29<sup>th</sup> November 2024

Please find attached the plans for 12 Parkway, Warwick, and the justification as required.

Refer to site plan A101 - elevation a - South fence line.

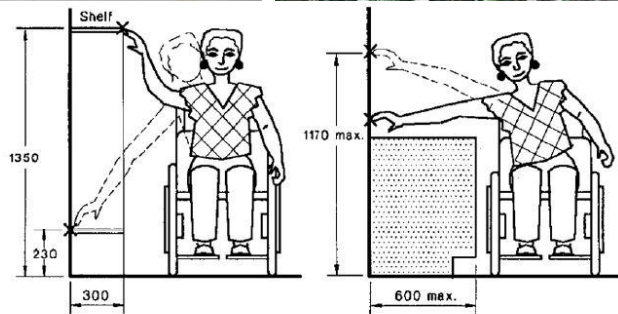
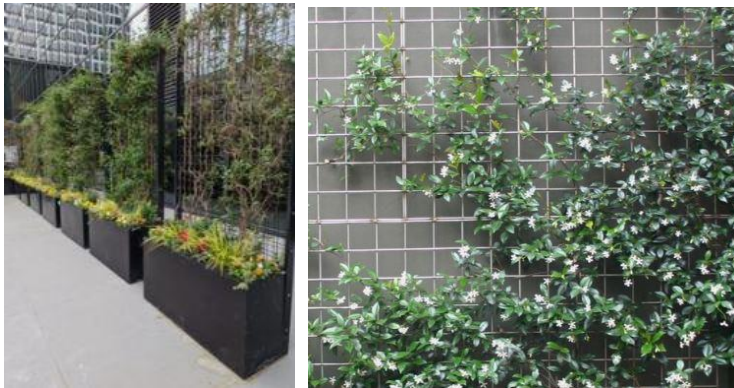
3 Privacy overlooking - visual screenings by way of Slat fence extension panels on top of 1.8m Colorbond fence to provide additional privacy for the neighbouring property = total length 22m in total  
The new proposed development site and floor levels are raised to allow step-free access into the residences. This has raised the property levels along the adjoining boundary of the south boundary.

There is no overlooking as the existing neighbouring property is 600 - 1000m below the new proposed level. Any view of the neighbouring property will be of the roof line and not into the winds of outdoor living areas.

Visibility will be to a roofline.

DIMENSIONS IN MILLIMETRES  
FIGURE 21 SIDE REACH WHEELCHAIR USERS

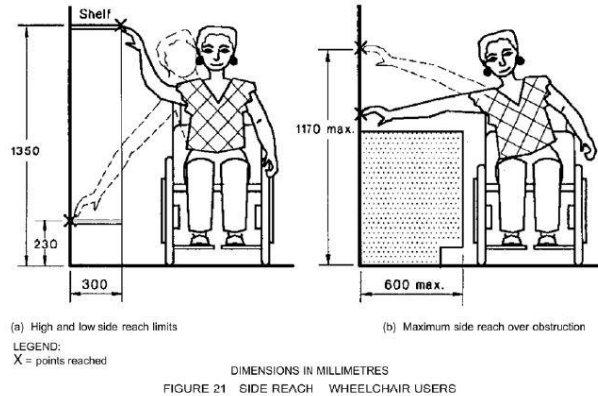
2 - Raised garden - Raised garden beds 600 to 800 high and a depth of no more than 350 mm will permit residents to have side approach access to the gardens to enjoy interacting with the plants  
reference Figure 21 from AS 1428.2 reach range for wheelchair users
